GIRDWOOD TRAILS PLAN

Public Review Draft – Recommendations for Changes/Edits

RE: GTP Public Review Draft

Recommended Changes

NS1: Virgin Creek Natural Space

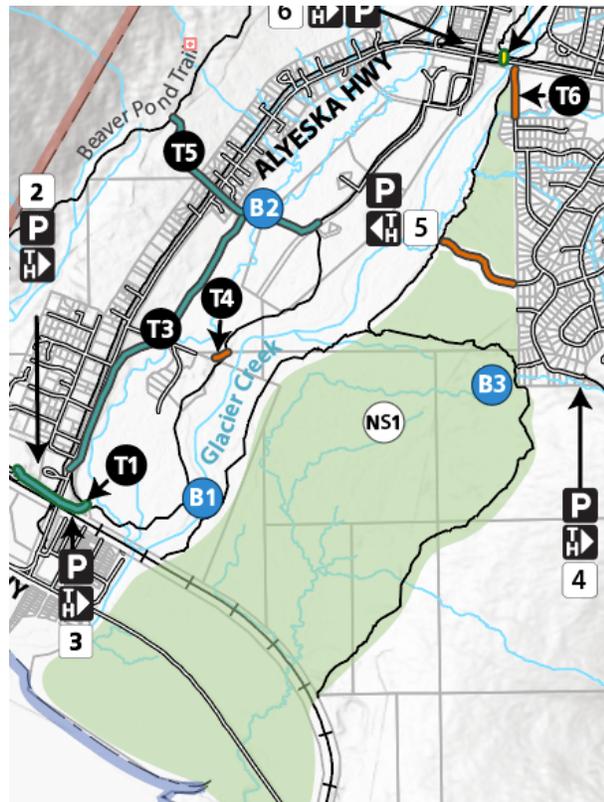
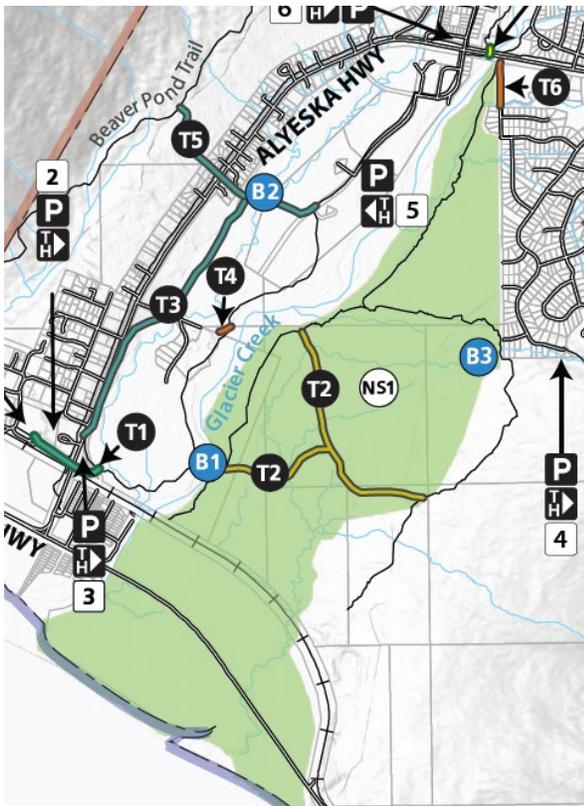
CHANGE RECOMMENDED

Recommend adjusting the boundary of NS1. The eastern boundary should extend and include the Wagon Trail. The western boundary should be adjusted to remove the Joe Danich Trail from NS1. ADD a trail project to the plan that brings the Joe Danich up to a Class 3 trail constructed to the bicycle design parameter and relocate out of wetlands to uplands. ADD trail project to the plan to construct neighborhood connector trail (Class 3, bicycle design parameters, constructed in uplands) from the Turin and/or Carlina

Drive cul-de-sacs to connect to the Joe Danich trail. NS1, with the adjusted boundary, remains non-mechanized with trails that are no greater than Class 2. Comments indicate that residents want a multi-use alternative trail to connect from the lower valley to the upper valley without using the road system. A Class 3 designation provides a sustainable connection to neighborhoods. The eastern boundary shift better aligns with a primitive experience for the Wagon Trail.

NS2: Stumpy’s Natural Space

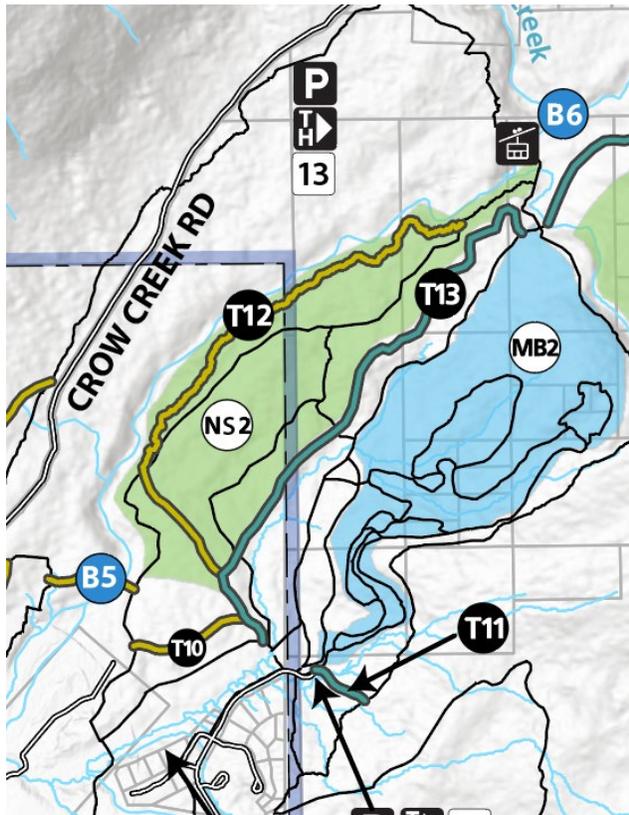
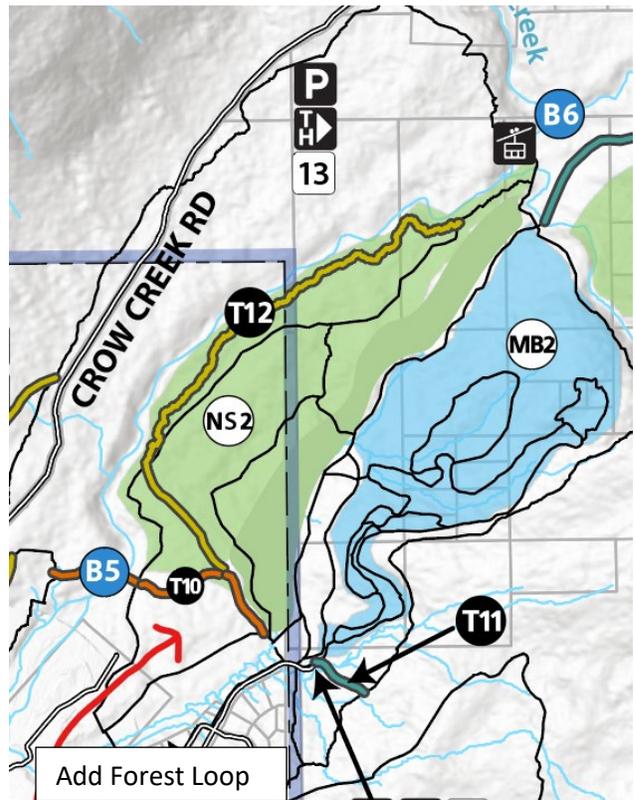
CHANGE RECOMMENDED

Recommend adjusting the boundary of NS2. Expand the boundary to the east to extend up to but not including the Snowcat Trail and the groomed section of Stumpy’s winter trail. (T13-Upper Valley Multi-Use Trail recommended to be removed from the draft plan and add Forest Loop back).

MB1: Beaver Pond MB Area

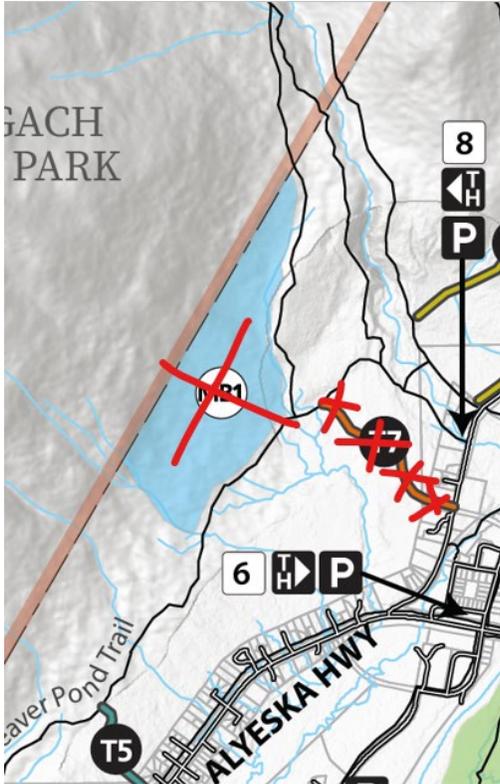
CHANGE RECOMMENDED – Remove MB1 from the plan:

There is not consensus about this project. Needs more discussion – if included in the plan MB1 shall be developed in consultation with the Girdwood Trails Committee only after MB2 is complete. If MB1 is removed, user conflicts on Abe’s and California Creek Trails still need to be addressed.

KEEP MB1 in the PLAN

NS1: Virgin Creek Natural Space

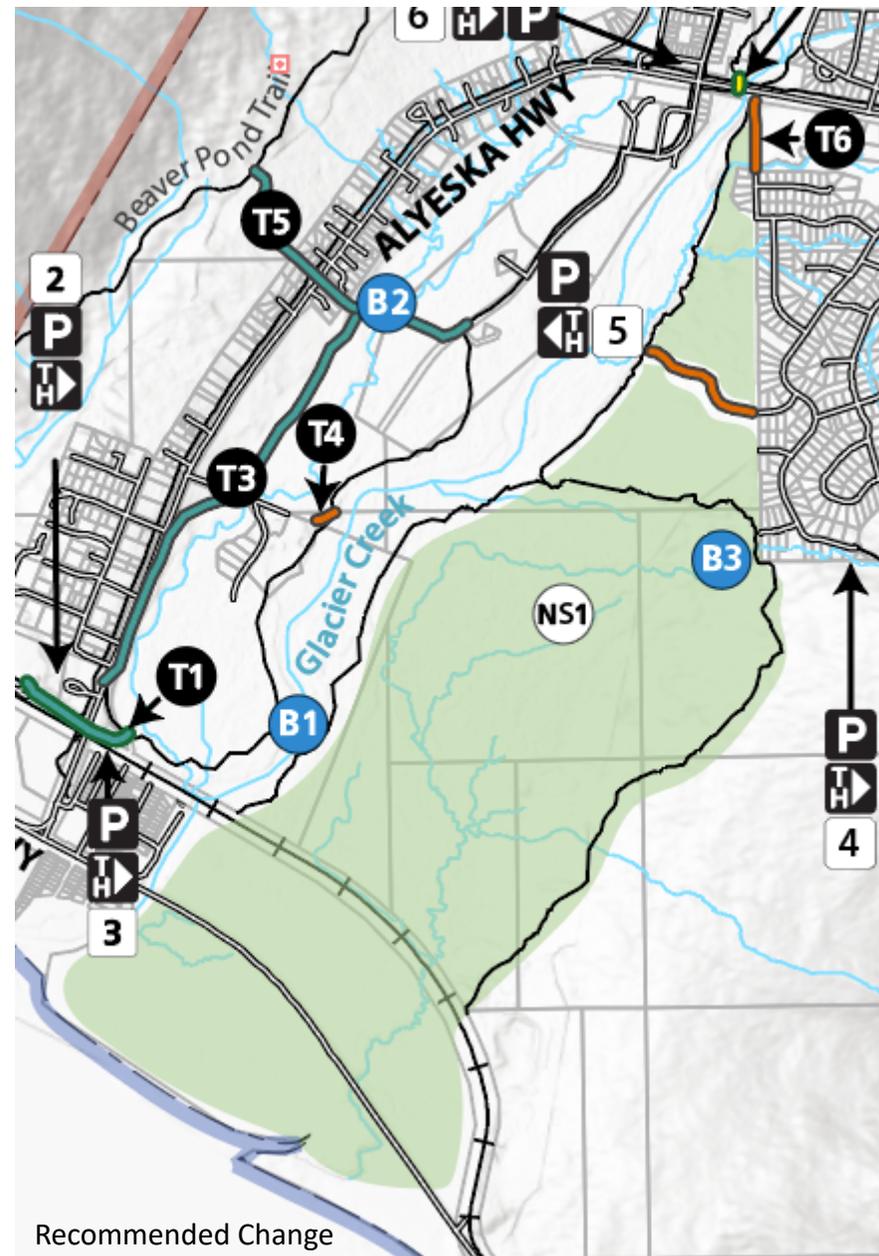
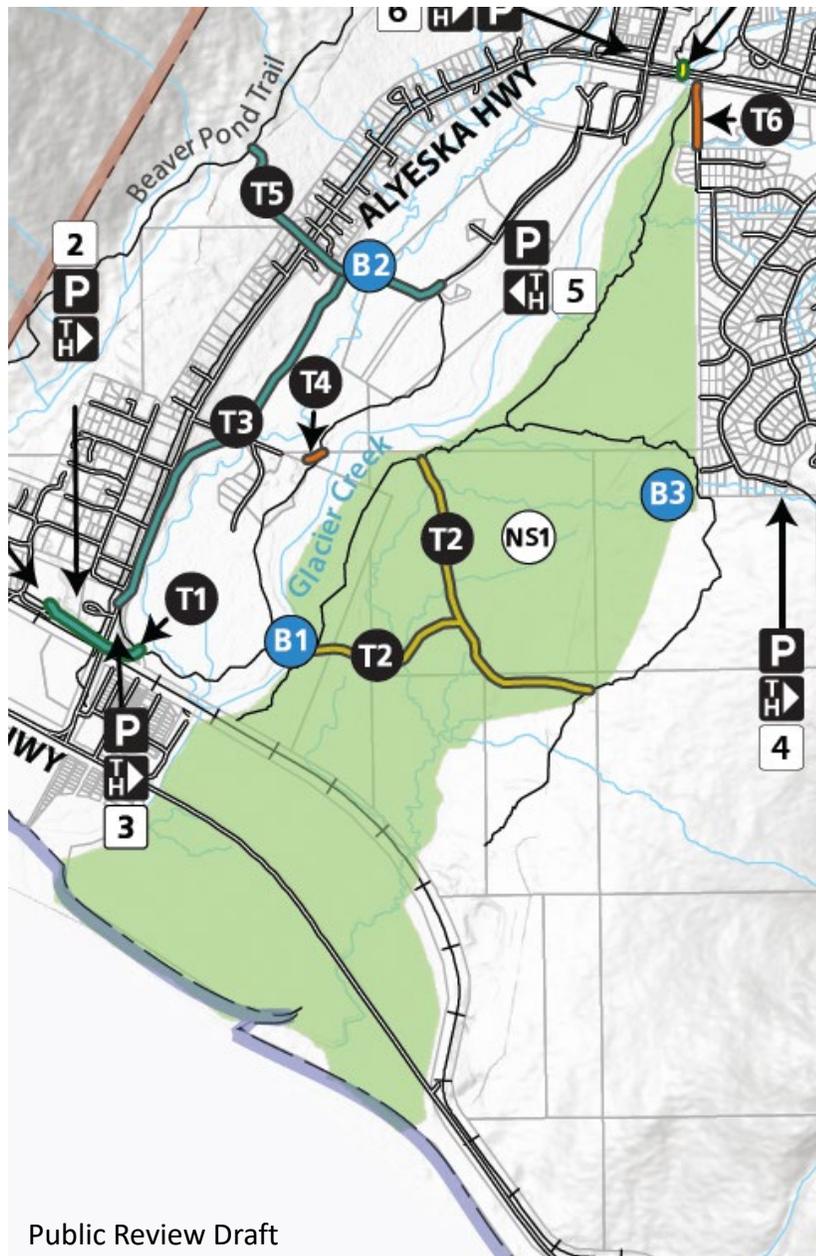
CHANGE RECOMMENDED

Recommend adjusting the boundary of NS1. The eastern boundary should extend and include the Wagon Trail. The western boundary should be adjusted to remove the Joe Danich Trail from NS1. ADD a trail project to the plan that brings the Joe Danich up to a Class 3 trail constructed to the bicycle design parameter and relocate out of wetlands to uplands. ADD trail project to the plan to construct neighborhood connector trail (Class 3, bicycle design parameters, constructed in uplands) from the Turin and/or Carlina Drive cul-de-sacs to connect to the Joe Danich trail. NS1, with the adjusted boundary, remains non-mechanized with trails that are no greater than Class 2. **WHY:** Comments indicate that residents want a multi-use alternative trail to connect from the lower valley to the upper valley without using the road system. A Class 3 designation provides a sustainable connection to neighborhoods. The eastern boundary shift better aligns with a primitive experience for the Wagon Trail.

NS2: Stumpy’s Natural Space

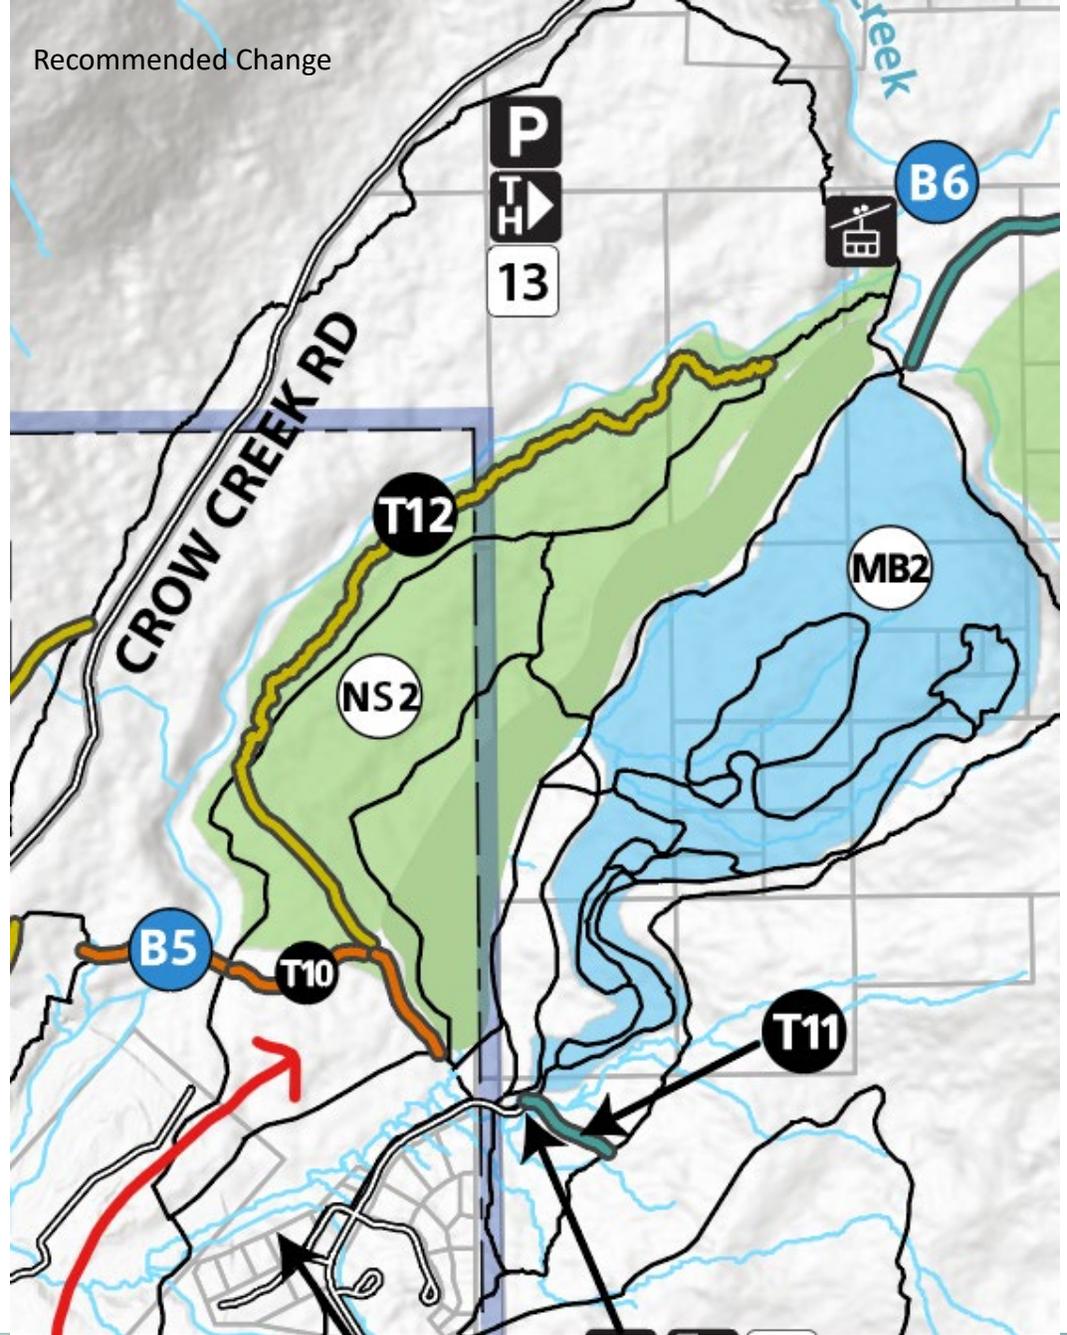
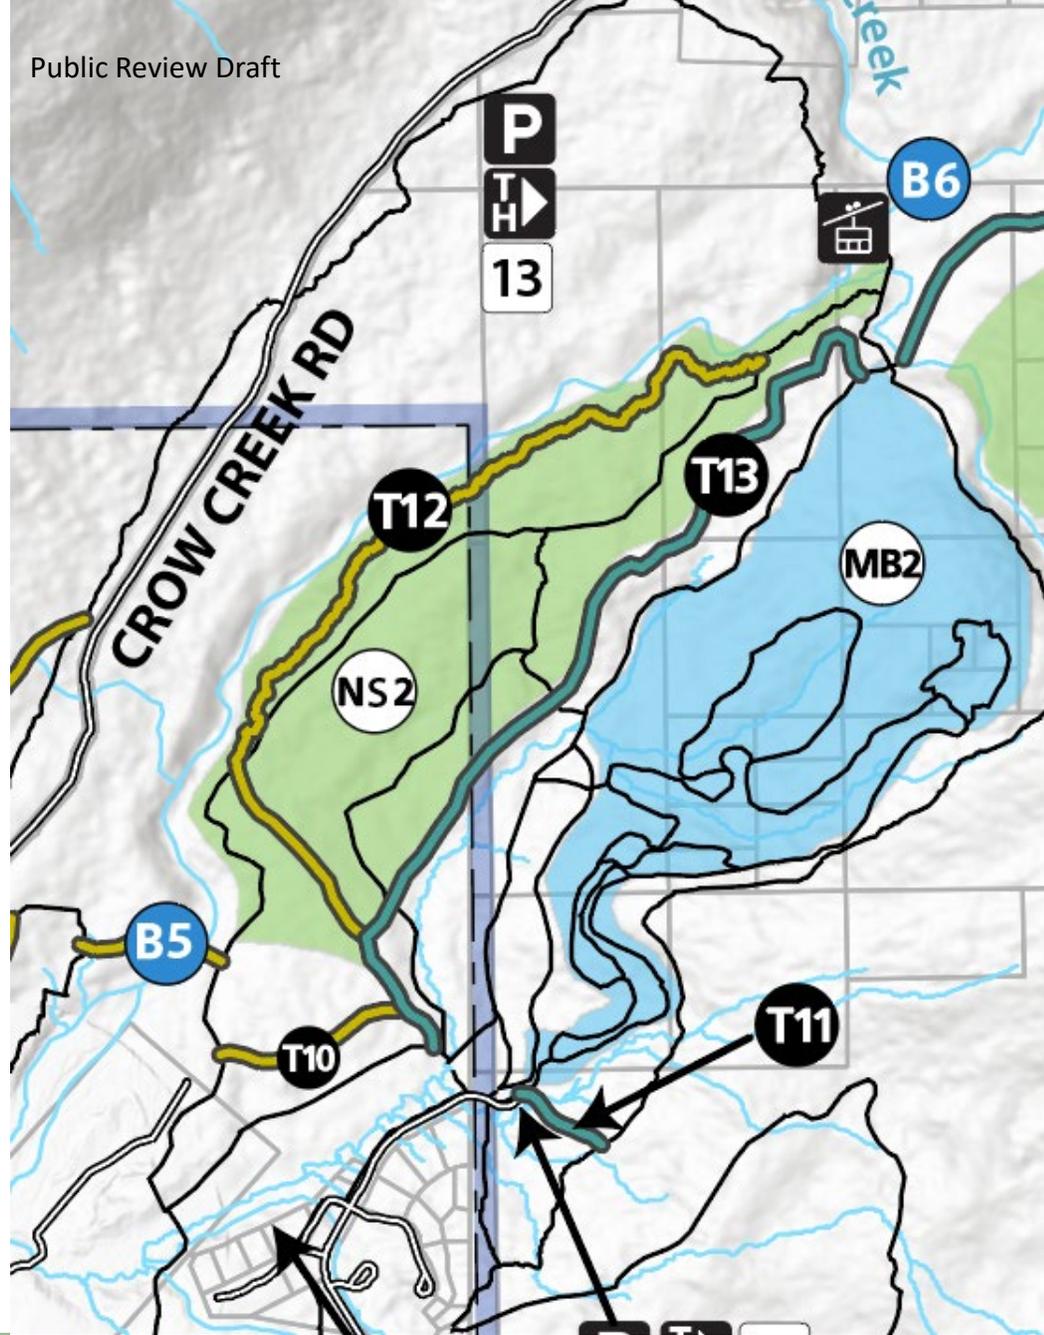
CHANGE RECOMMENDED

Recommend adjusting the boundary of NS2. Expand the boundary to the east to extend up to but not including the Snowcat Trail and the groomed section of Stumpy’s winter trail. **WHY:** There isn’t consensus for T13 and the wetlands are better suited for a more primitive experience.

ADD FOREST LOOP

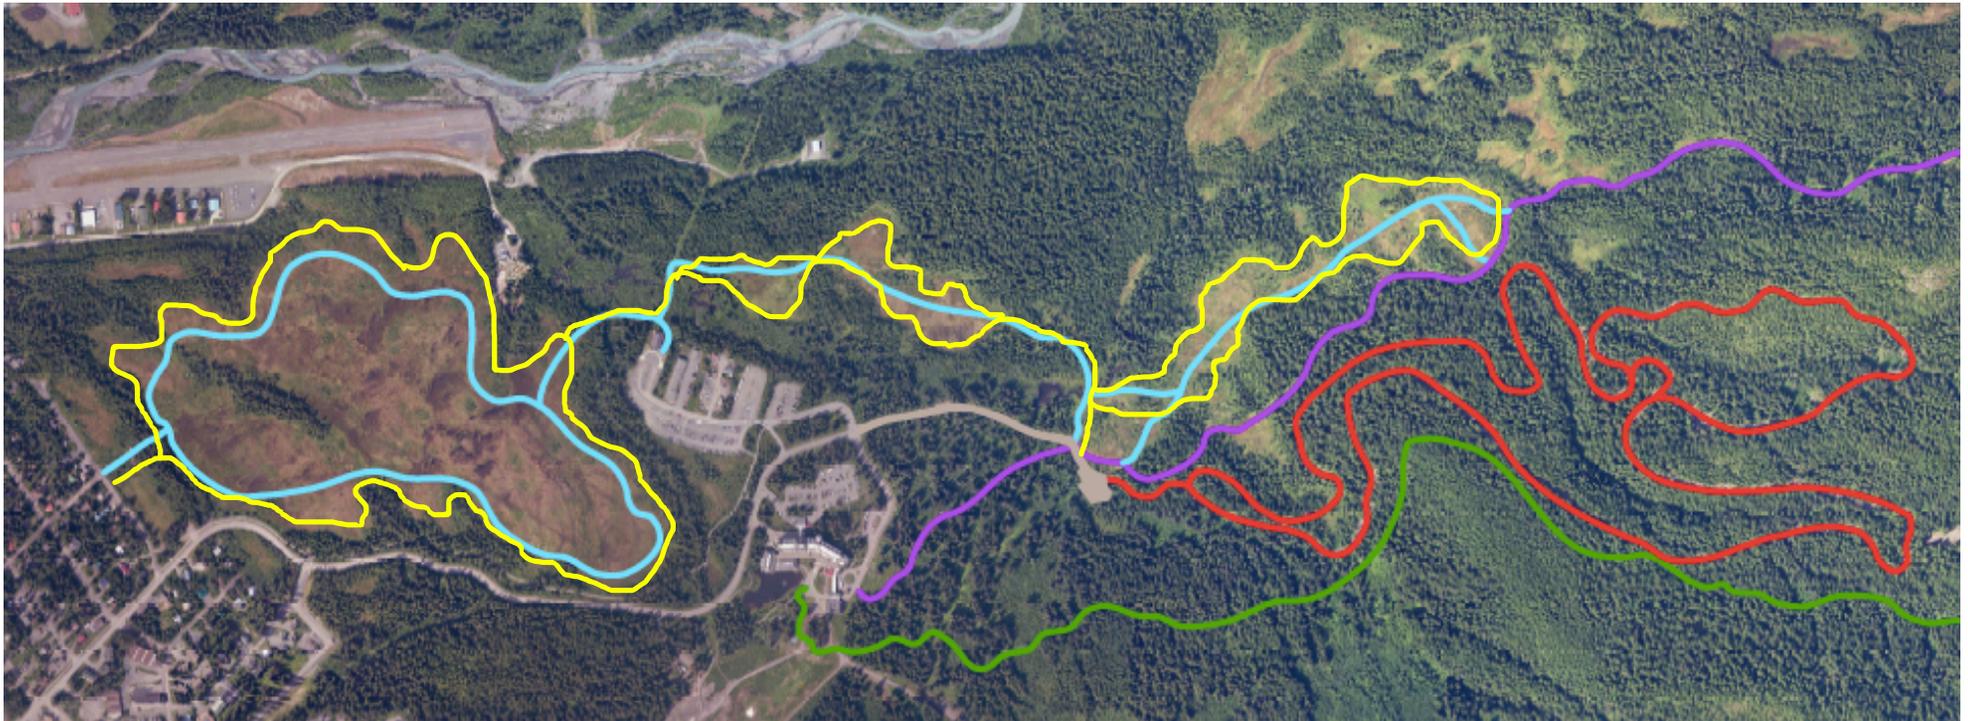
Yellow line indicates proposed narrow gauge grooming route. An outer Viewscape loop similar to Moose Meadow to continue up valley connecting the meadows. This could increase the hiking, biking, and skiing user-days with a lighter and more maneuverable grooming machine. This is a response to the positive feedback of the Moose Meadow loop and to create a safe route for the increasing number of multi-use trail users in Girdwood.
